REQUESTOR NAME: **BC Sustainable Energy Association**

TO: **FortisBC Inc. (FBC)**

DATE: **October 26, 2012**

APPLICATION NAME: **Application for a Certificate of Public Convenience and Necessity (CPCN) for the Advanced Metering Infrastructure (AMI) Project**

Figure 1: Source: *The Canadian Smart Grid Standards Roadmap: A strategic planning document*, Standards Council of Canada, October 2012, Section 5.2, Page 27, Figure 5; [with red arrow and purple ovals added for emphasis]

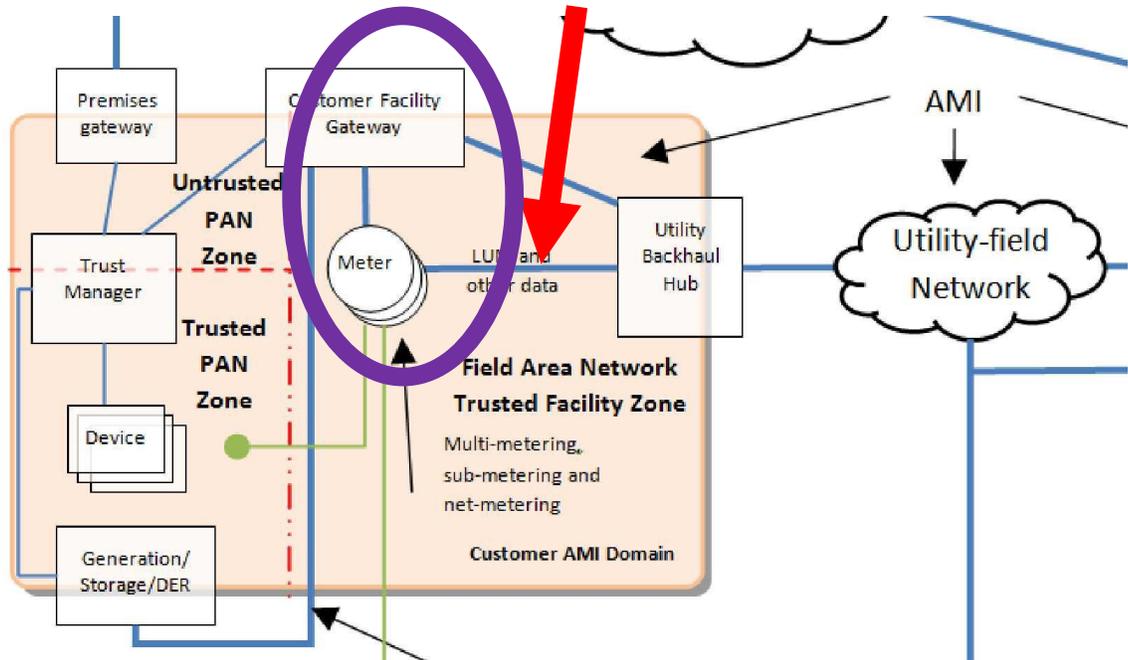
- 1.3.5.1 Please refer to FortisBC's response to IR 1.2.4 (regarding SMI Requirements concerning "transmits and receives information in digital form"¹⁴), above. Would FortisBC agree that the information listed in IR 1.2.4 is depicted by the red arrow (pointing to "LUM and other data") in Figure 1, above? If not, please explain.
- 1.3.5.2 It is noted that the "Canadian Smart Grid Roadmap" recommends communication of Legal Units of Measure (LUM)¹⁵. Does the proposed FortisBC AMI system communicate LUM at the location shown by the red arrow in Figure 1, above?
- 1.3.5.3 Does the proposed FortisBC AMI system meet all sections of Recommendation M2¹⁶? If not, please explain.
- 1.3.6 Considering that the "Logical AMI Diagram" shows a logical architecture, would FortisBC agree that the Itron meter with the ZigBee technology are generally described by the "Customer Facility Gateway" and Meter

together depicted by the purple circle in Figure 1 above? If not, please discuss.

Figure 1. Comparison of RF exposure from RF-Lan and Zigbee signals to RF exposure from other sources under typical use. RF-LAN and Zigbee exposure is for an outside exposure at a distance of 0.5 meters. Exposure at larger distances or inside the residence is much smaller.

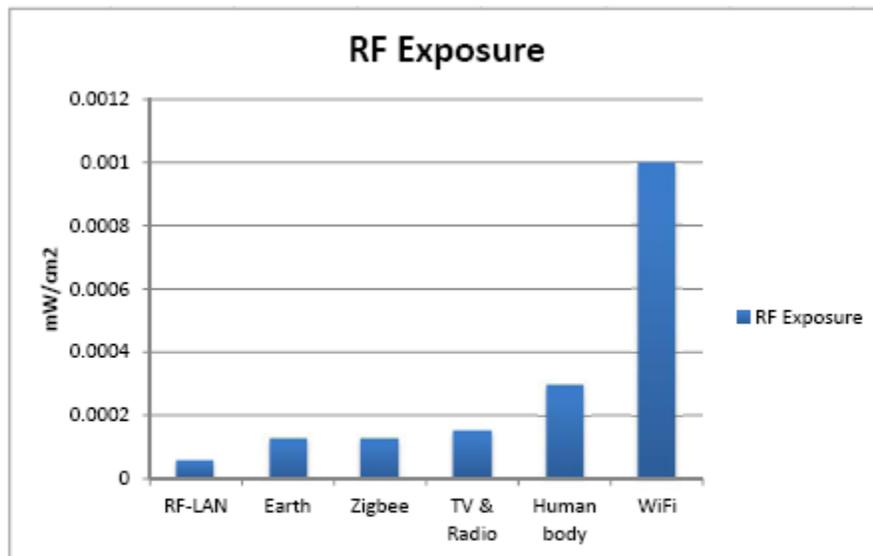
61.2 Confirm that Figure 1 shows various sources of RF Exposure that are at different frequencies and therefore the potential health consequences of the various sources do not necessarily correspond to the indicated RF Exposure.

61.3 Please provide a table and graph showing the various sources of RF Exposure as a ratio of the corresponding exposure limit, and include cell phone exposure referred to on p.A-5.
